FACILITIES PROGRAM UPDATE
SOUTHWEST APPLIED TECHNOLOGY COLLEGE
CEDAR CITY, UTAH
UTAH COLLEGE OF APPLIED TECHNOLOGY

PROGRAM
SUPPLEMENT
#1

JUNE 26, 2014

Frank N Murdock Jr Architect & Associates
975 East 100 South, Salt Lake City, Utah 84102

Revised
Page 185

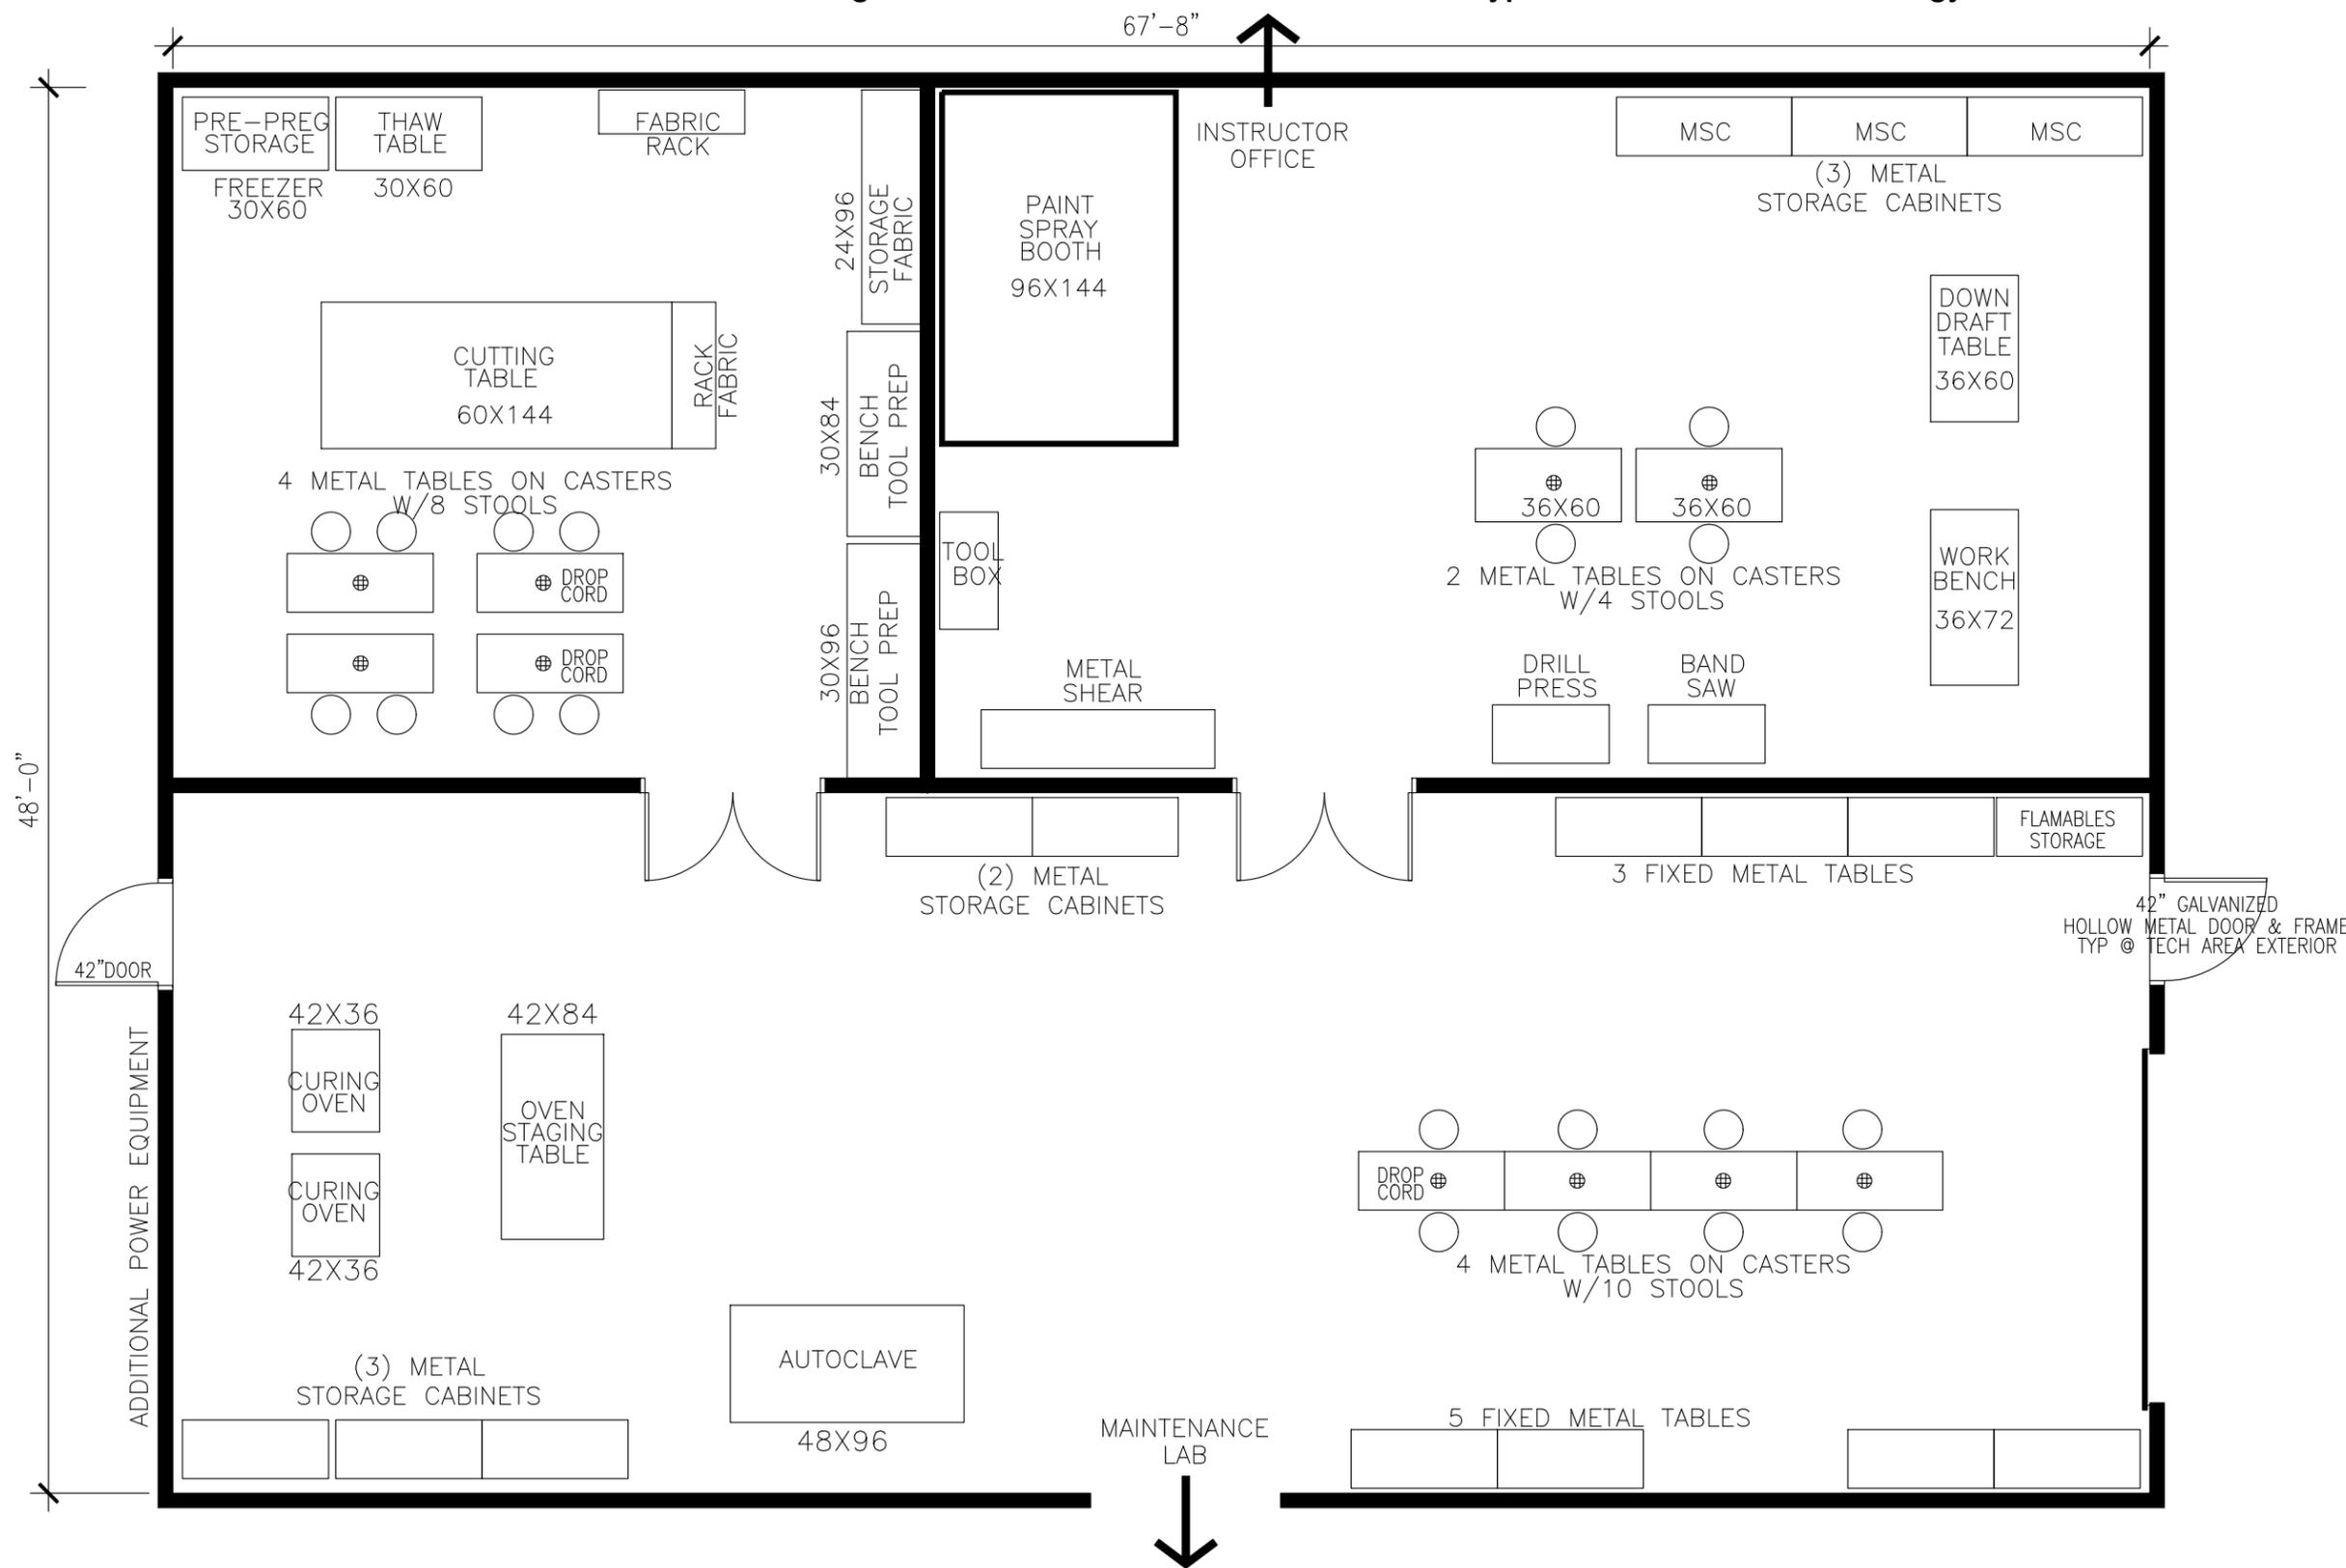
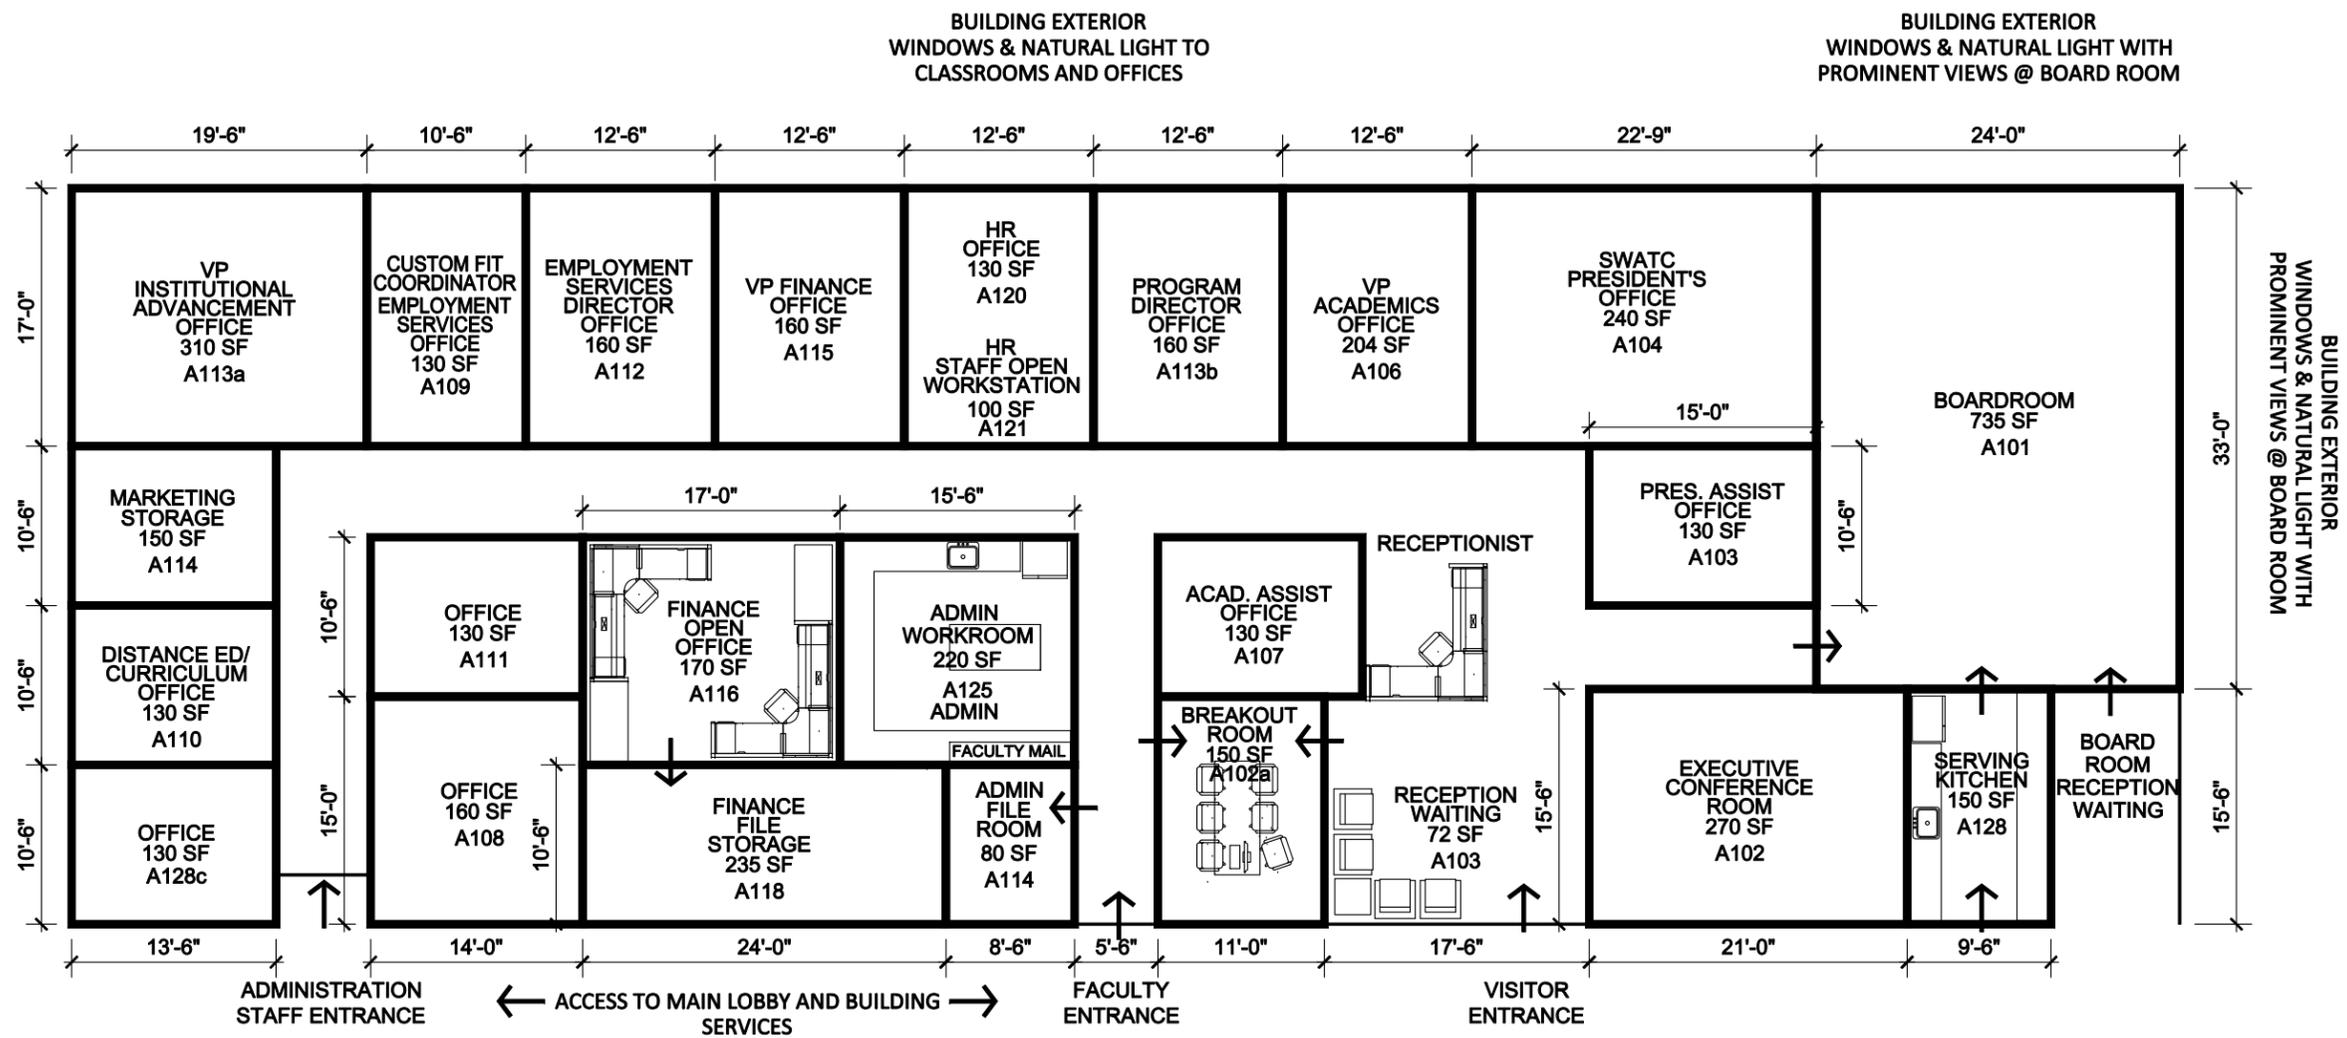
59. Page 182: Adjacencies: Change to; Industrial Labs & Instructor's Offices
60. Page 184: Equipment & Electrical: See Attachments, Revised Page 185 Industrial Maintenance Lab T114 for additional equipment and Electrical requirements. 230 volt 3 phase power is required. Provide power at drop cords in locations indicated. Confirm power requirements for selected equipment typical.

61. Page 185: Replace with Attachments, Revised Page 185 Industrial Maintenance Lab T114.
62. Page 188: Casework & Fixed Equipment: Move all cabinetry items to Moveable Furnishings. Delete reference to Fixed ceiling mounted projector.

In addition to the original Program requirements, add outlets for the additional power operated equipment shown. Also add overhead power cords in the locations indicated. Provide and install minimum 42" galvanized hollow metal door and frames typical at all exterior Technology area exterior man doors.

Revised
 Page 229
 Adimin

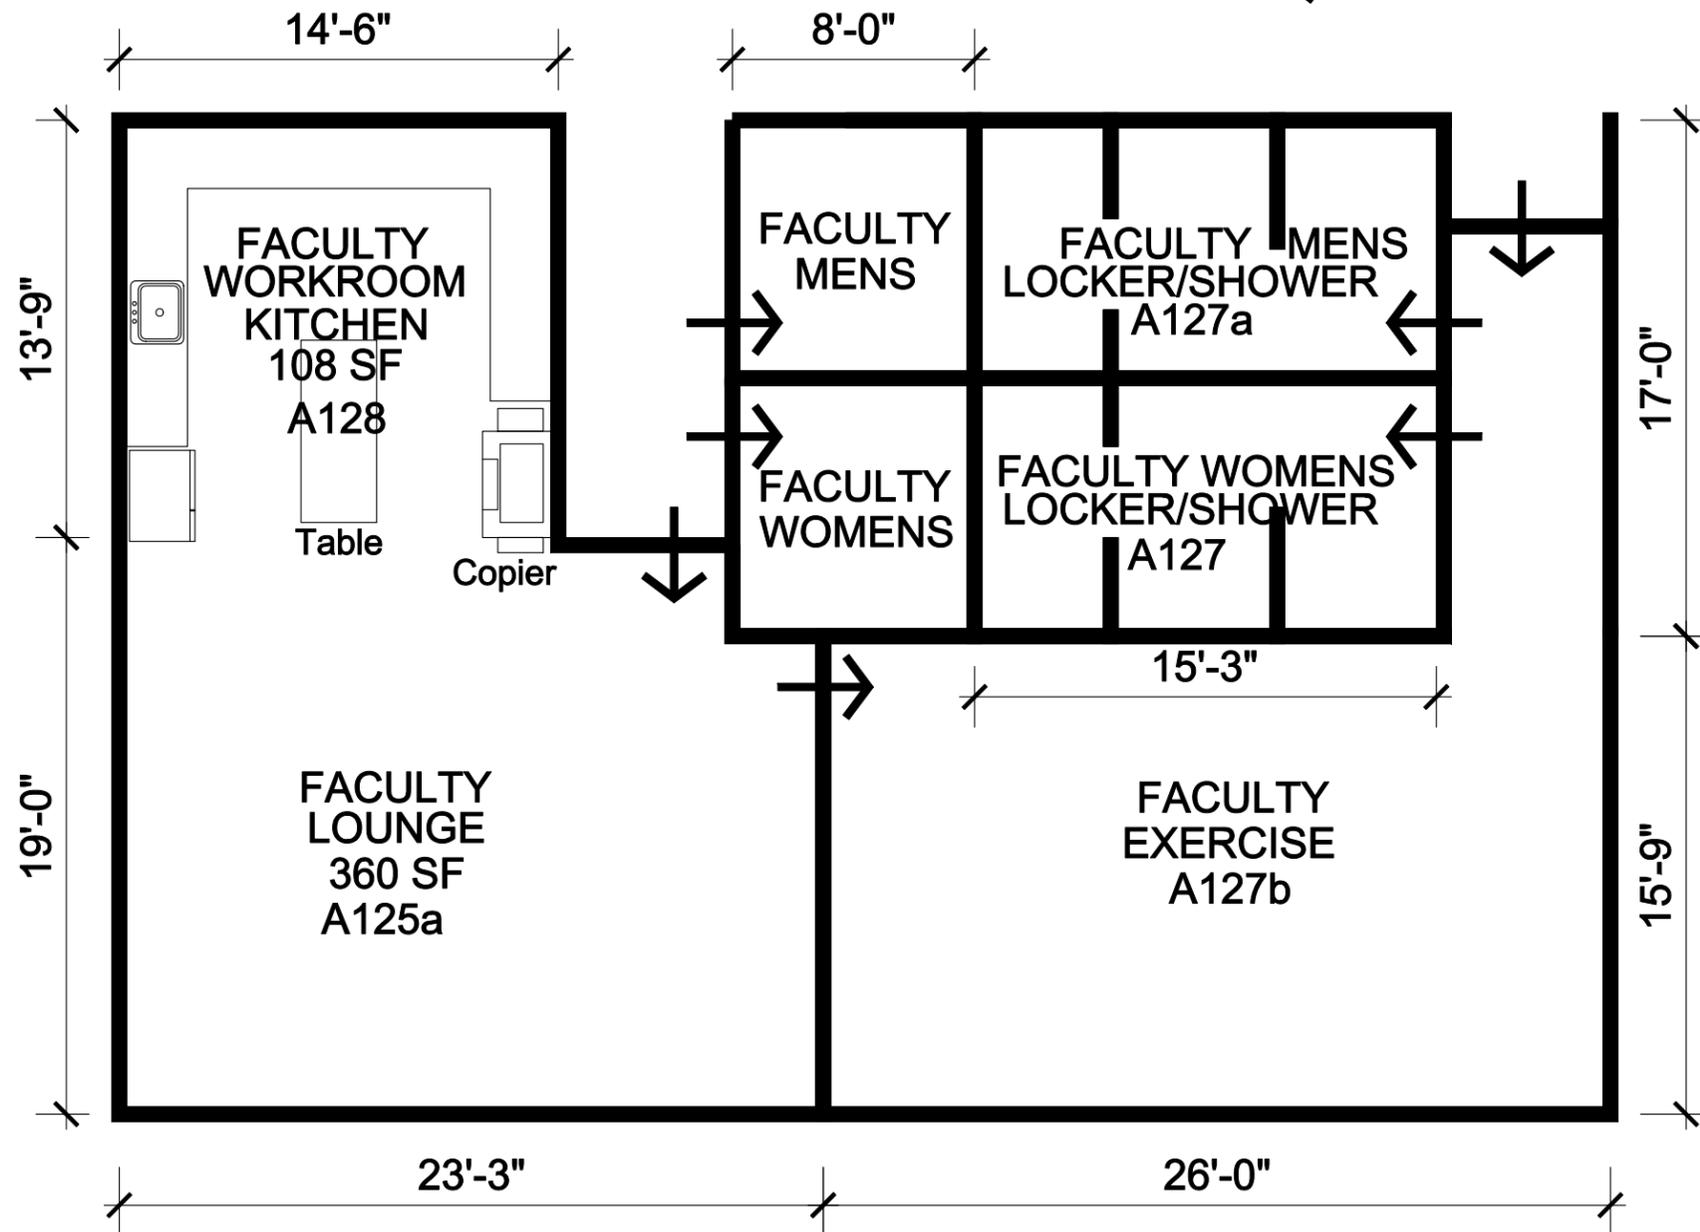
72. Page 228: Relationship Diagrams: The Relationship Diagrams indicate an option and are not to be taken as required relationships. See Note 45 above
73. Page 229: Adjacency Diagrams: Administration Adjacency Diagram: Delete pages 229 and replace with Attachments, Revised Page 229 Administration Adjacency Diagram.

The Faculty Locker and Shower Rooms should be designed for single occupancy. Space should be provided in the Faculty Work Room/Kitchen for a copy machine, sink and refrigerator as indicated.
